METROPOLITAN GOVERNMENT OF NASHVILLE AND DAVIDSON COUNTY

STAFF RECOMMENDATION
3613 Richland Avenue
Lot 11, Richland Hall Development
June 21, 2017

Application: New construction—infill and outbuilding
District: Richland-West End Neighborhood Conservation Zoning Overlay
Council District: 24
Map and Parcel Number: TBD
Applicant: Chad Gore, Mike Ford Builders
Project Lead: Melissa Baldock, melissa.baldock@nashville.gov

Figure 1. Lot at 3613 Richland Avenue

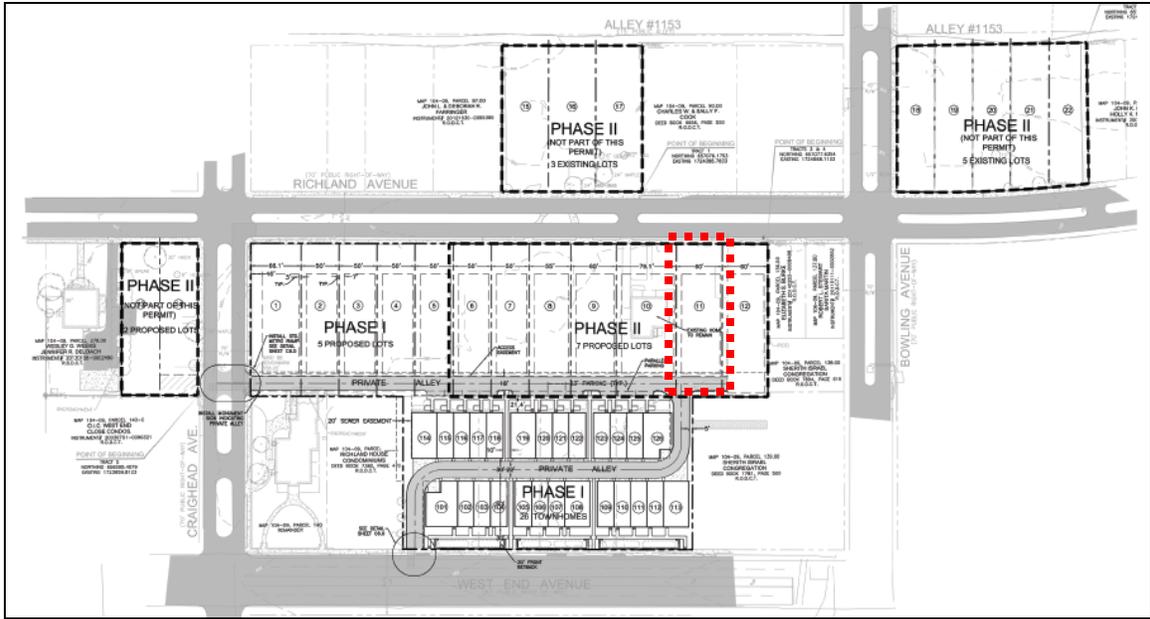
Background: 3613 Richland Avenue is a currently a vacant lot. It is adjacent to the historic Davidson Hall (Figure 1). Formerly on the site was a non-contributing building that was part of the Welch College (formerly the Free Will Baptist Bible College) campus. The College has moved to a new location and the building has been demolished. In June 2015, the Metro Historic Zoning Commission approved a preliminary site plan for 22 new infill houses on the former campus, all located within the Richland-West Neighborhood Conservation Zoning Overlay (Figure 2). The Commission’s approval was contingent on the applicant returning to the Commission for approval of all infill design and site layout. To date, MHZC has approved infill and outbuildings for Lots 1, 2, 3, 4, 5, and 6 (3657, 3653, 3649, 3641, 3637, and 3633 Richland Avenue, respectively). Several of these houses have been constructed (Figure 3).

C2
 SITE PLAN

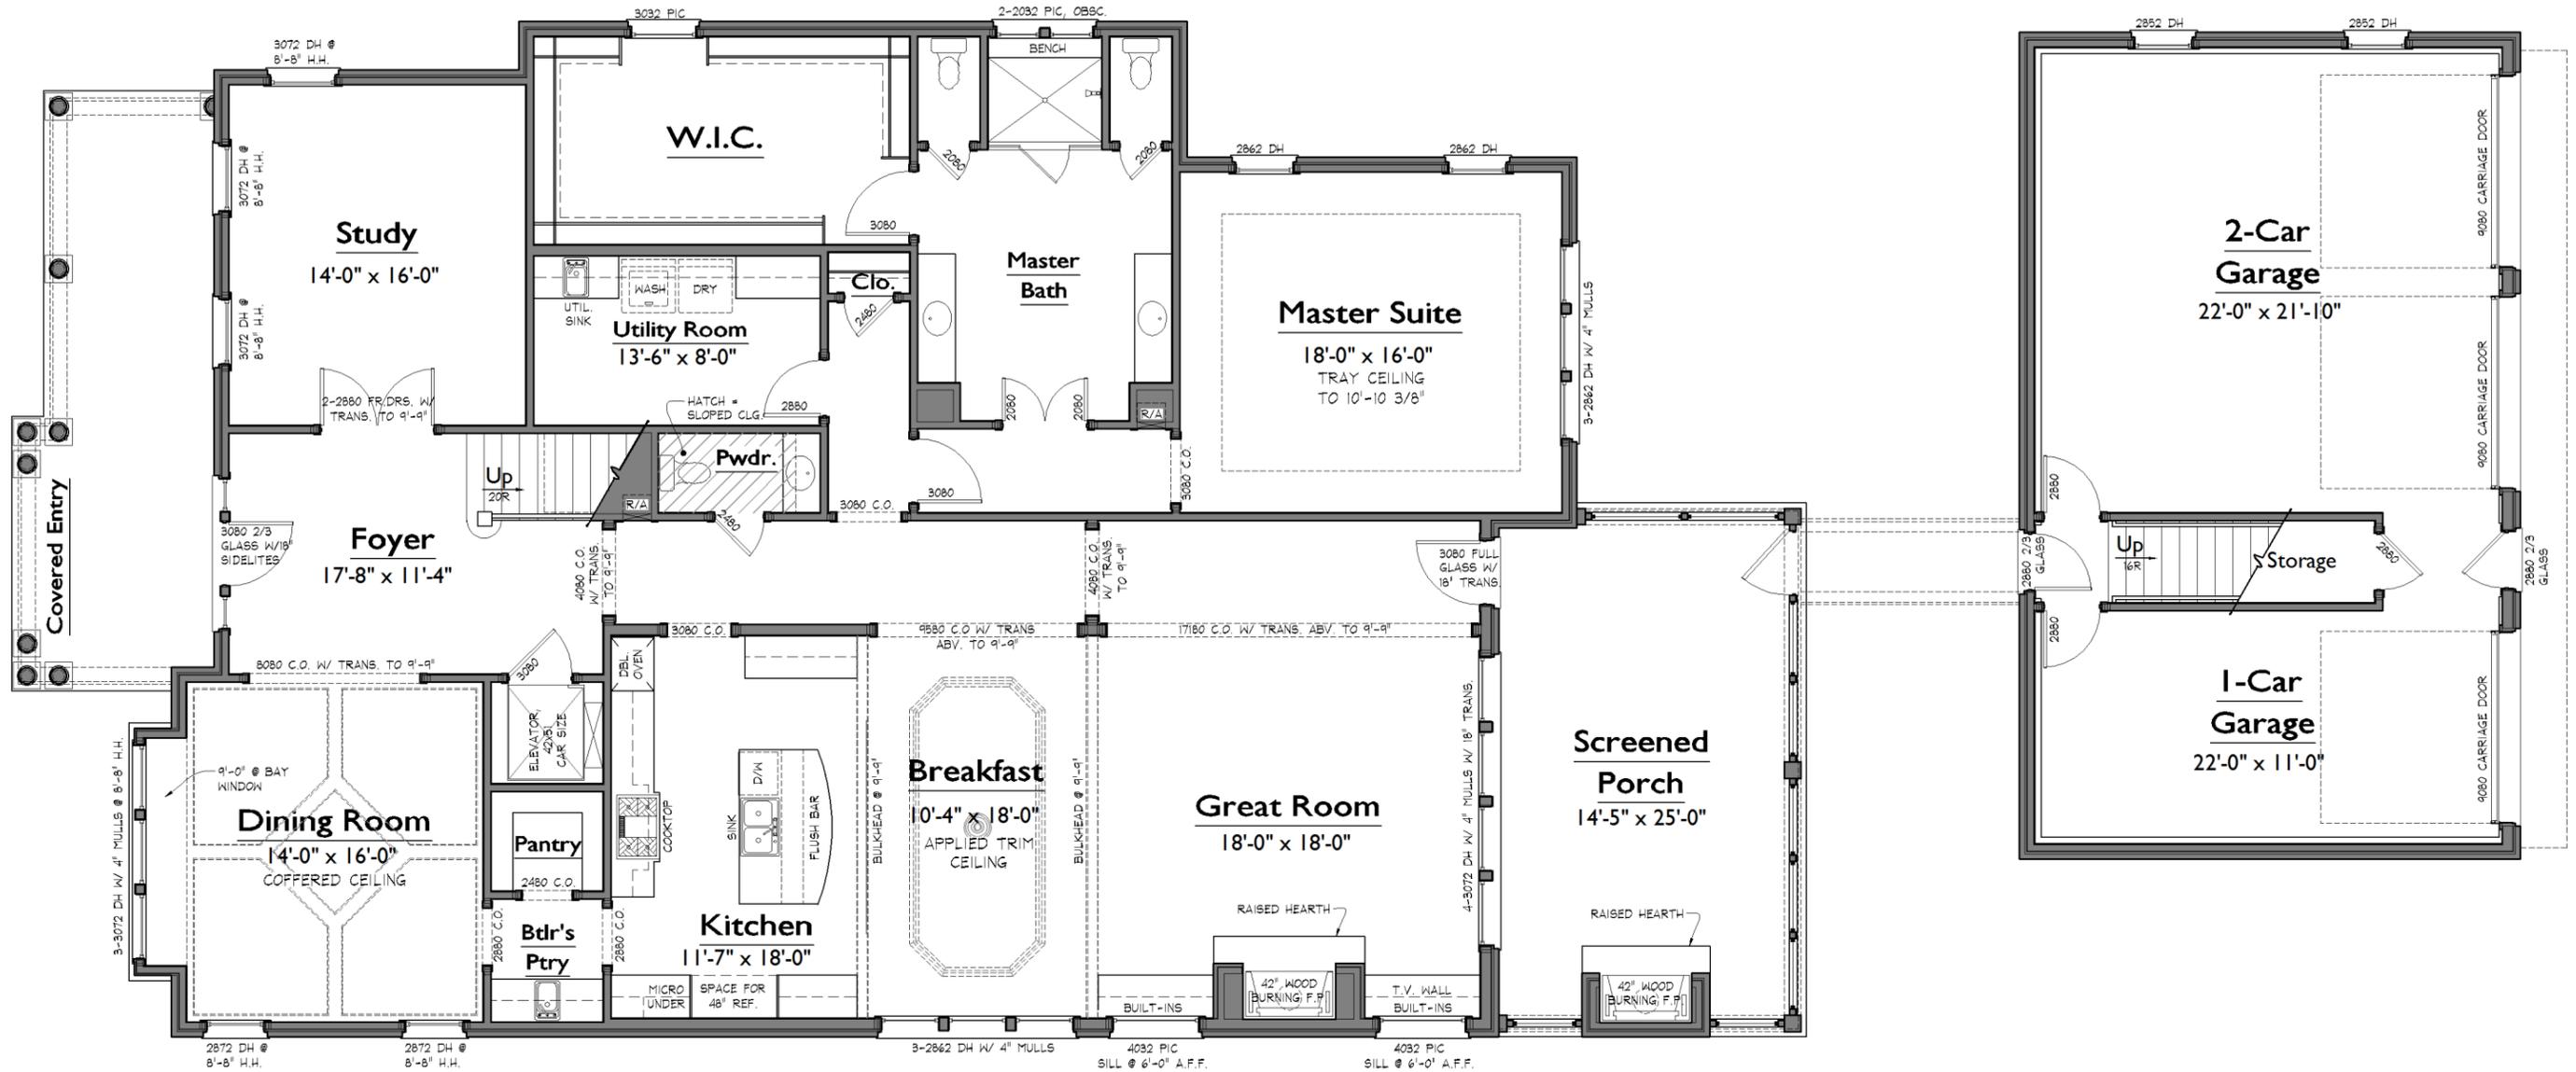
Setback & Rhythm of Spacing: The proposed infill will meet all base zoning setbacks. The six infills that MHZC has approved for this development to date have had front setbacks of forty feet (40'). The front setback for this development is proposed to be larger at fifty-three feet (53') in order to better transition from the setback of the historic Davidson Hall immediately to the right, which has a front setback of seventy feet (70'). Staff finds that the proposed front setback meets the design guidelines and the historic context.

The infill will be at least five feet (5') from the left side property line and will be seven feet (7') from the right side property line. It will be over sixty-five feet (65') from the rear property line. Staff finds that the proposed setbacks to be similar to the immediate historic context and to meet Section II.B.1.c. of the design guidelines.

Appurtenances & Utilities: The driveway at the rear will be concrete, as will the walkway leading to the front porch from the sidewalk. No fencing was indicated on the site plan. The HVAC unit will be located on the right side elevation, about thirty feet (30') back from the front of the house. Staff finds that the infill meets Section II.B.1.i. of the design guidelines.

*The Commission typically requests to see at least twenty feet (20') between the primary structure and the outbuilding. The applicant is proposing just ten feet (10') in between the structures. The Commission has approved a distance of ten feet (10') in between the primary structures and the outbuildings for Lots 1, 2, 3, 4, and 5 of this development. Staff recommends approval of the distance between the infill and the outbuilding for Lot 11. The overall development is creating a new alley at the rear of the lots, which will make the back portion of the lot unavailable for building. Approximately the back thirty feet (30') of the lot is used for the alley. In addition, there is a utility easement in between the alley and the outbuilding. The outbuilding cannot be pushed any further to the rear because of the new alley and the easements on the property. Therefore, staff finds that the distance in between the primary house and the outbuilding to be sufficient.

1 FRONT ELEVATION
1/4" = 1'-0"

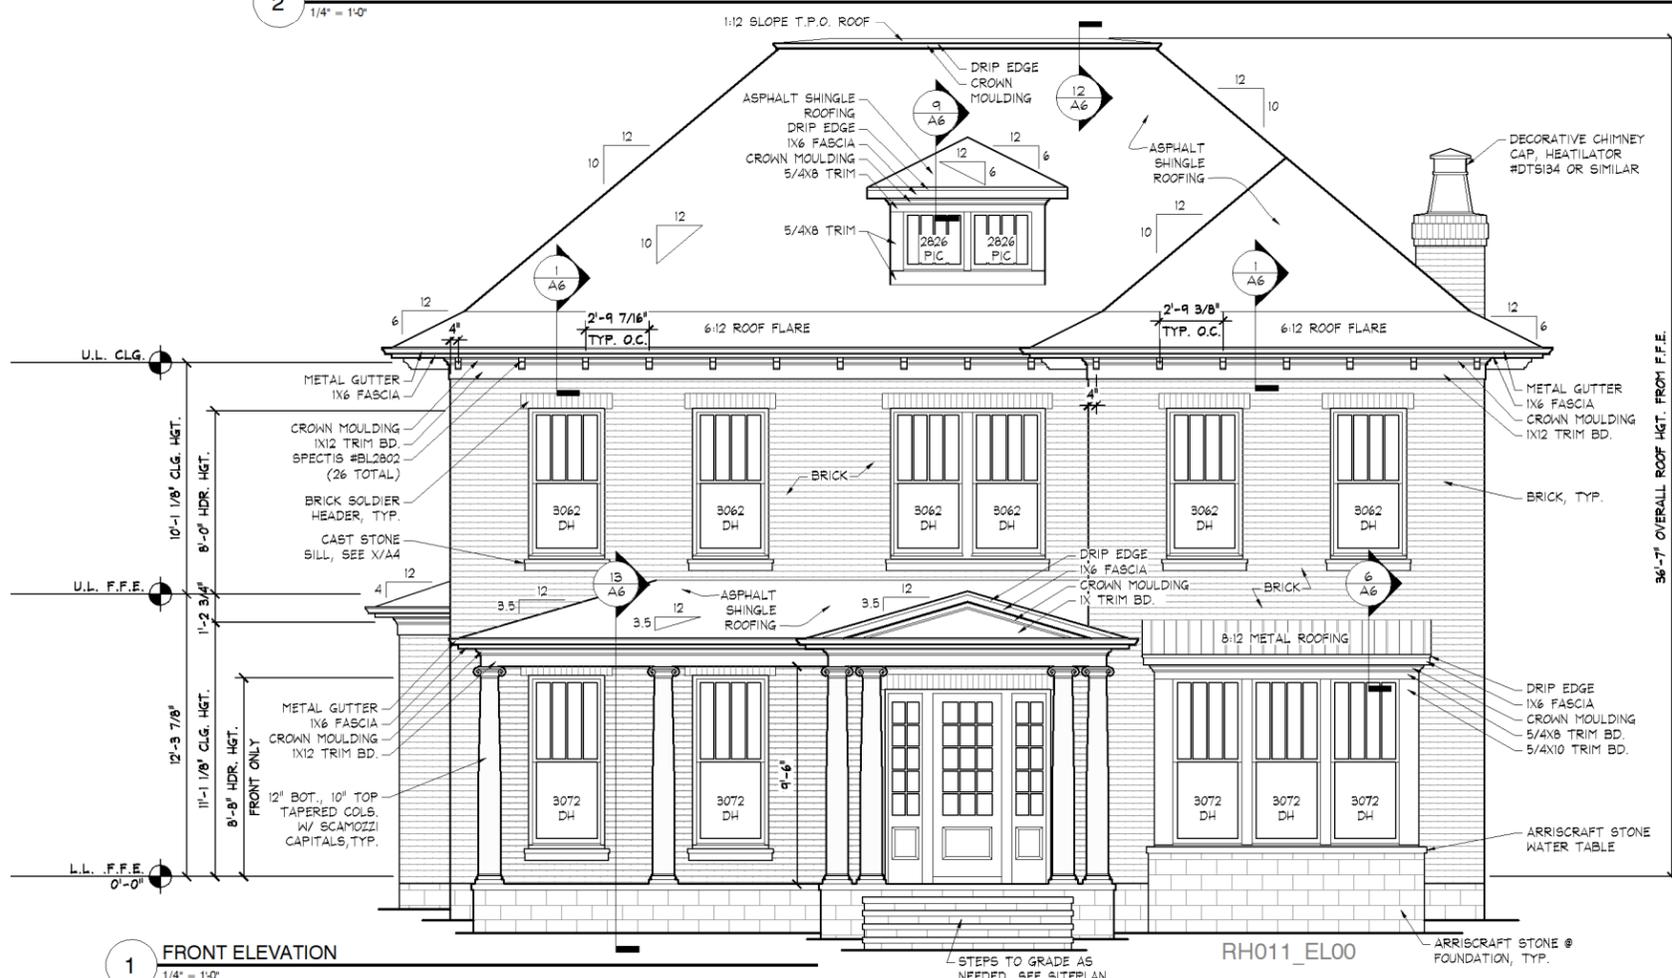
Height & Scale: The proposed infill will be two stories, with a maximum height of thirty-six feet, seven inches (36'7") above the foundation at the front, and approximately

thirty-nine feet (39') above grade. The infill will have an eave height of twenty-five feet (25') above the grade at the front. The foundation height will vary due to grade, but will be between eighteen and twenty-four inches (18"-24") at the front. Staff finds that the proposed height is similar to the heights of historic houses in the immediate vicinity, which range from thirty to forty-four feet (30' – 44'). It is also in keeping with what has been approved in the past for the infill houses in this development.

Roof form: The infill's primary roof form is a hipped roof with a 10/12 pitch. A projecting bay on the front will also have a hipped roof form with a 10/12 pitch. The front dormer will be hipped with a 6/12 pitch; the dormer will be inset four feet (4') from the wall below. The front porch roof will have a 3.5/12 hipped roof, and the one-story bay on the left side will have a 4/12 hipped roof. The rear porch roof will be a 6/12 hip. Staff finds that the proposed roof forms are appropriate for a two-story infill house in the overlay, and finds that the roof forms meet Section II.B.1.e. of the design guidelines.

Proportion and Rhythm of Openings: The proposed windows on the infill are generally twice as tall as they are wide, thereby meeting the historic proportion of window openings. There is an expanse of twenty feet (20') without a window or door opening on

Staff recommends verification of the construction height of the foundation and floor systems in the field to ensure that the finished floor line of the new construction is compatible with the historic context. With this condition, staff finds that the height and scale meet Sections II.B.1.a.andII.B.1.b. of the design guidelines.

1 LEFT ELEVATION
1/4" = 1'-0"

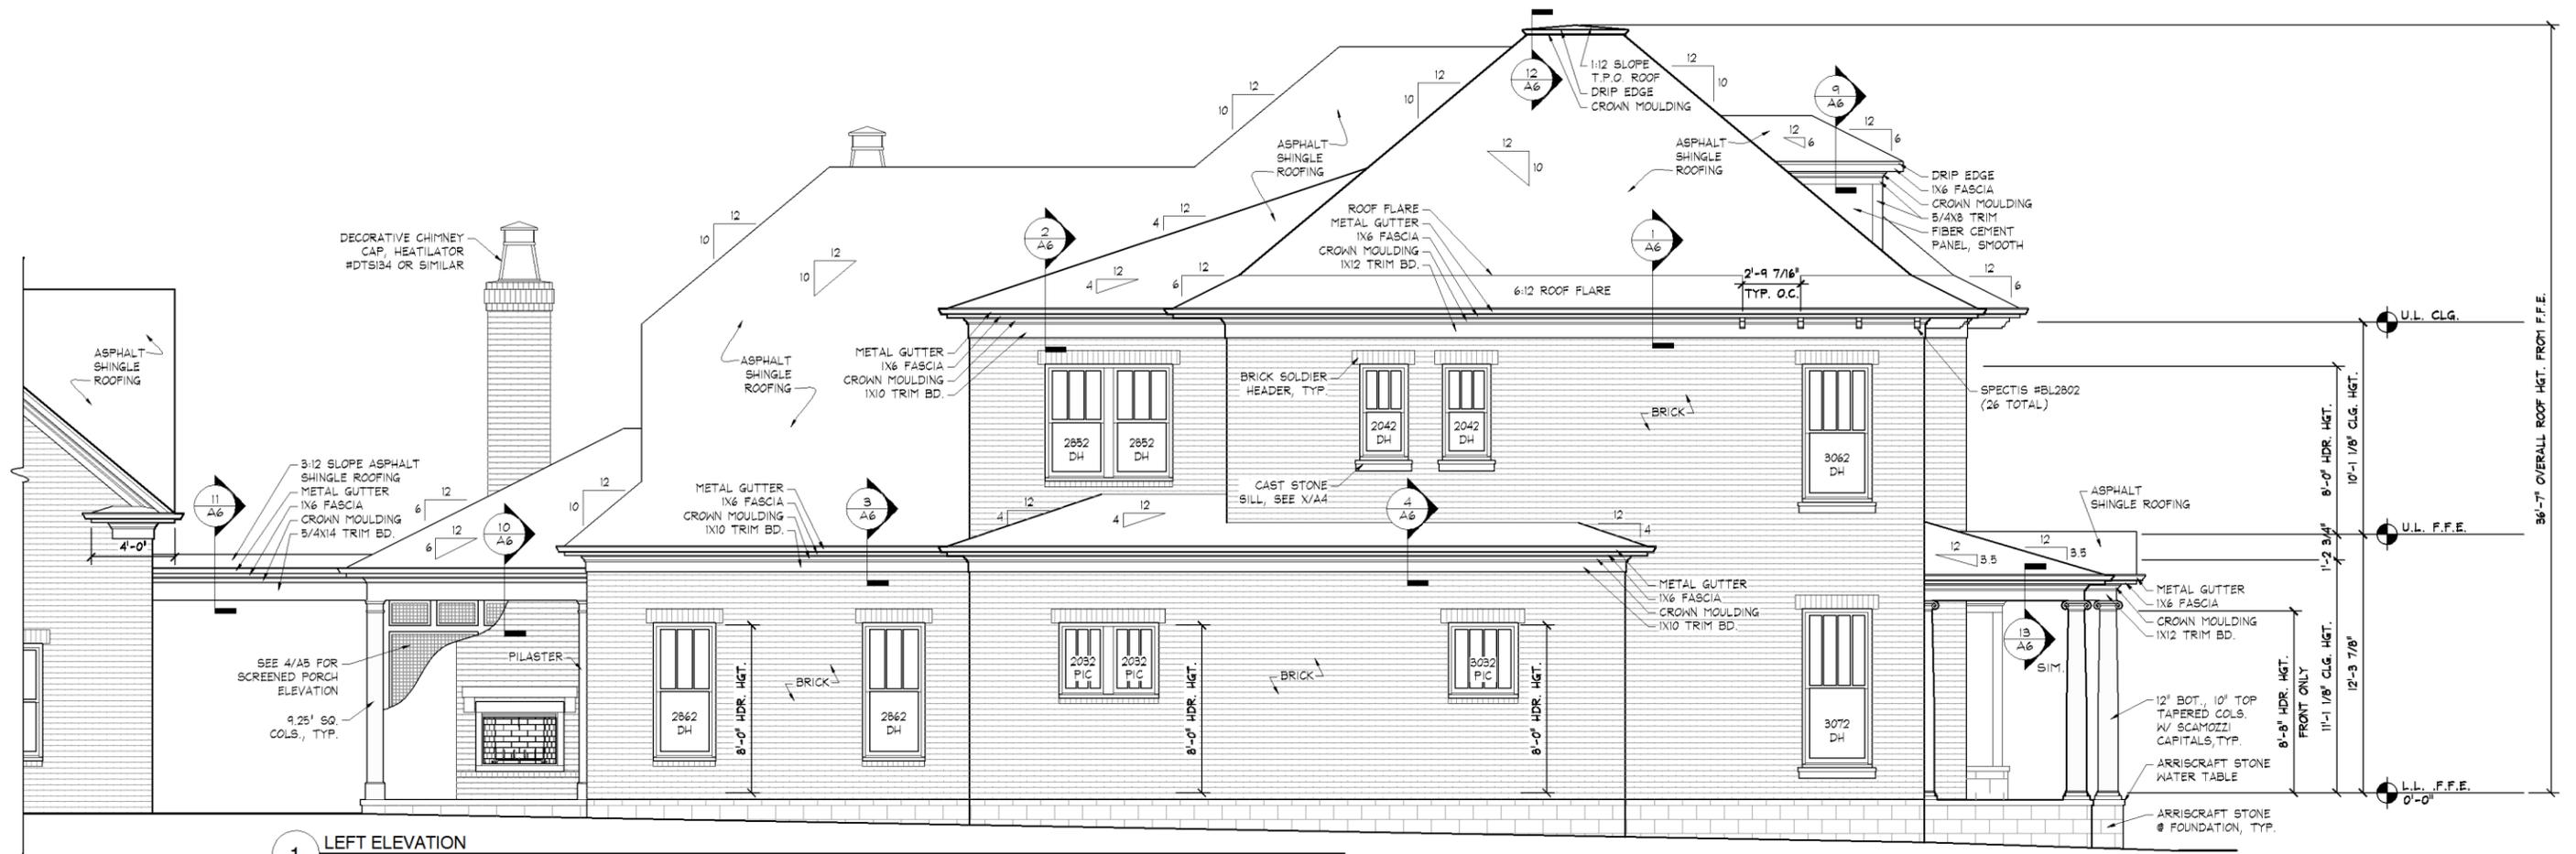
the left façade, ground floor. Staff finds this expanse to be appropriate because it is located at the midpoint of the house and will not be highly visible. All double and triple window openings have a four to six inch (4"-6") mullion in between them. Staff finds that the infill's proportion and rhythm of openings meet Section II.B.1.g. of the design guidelines.
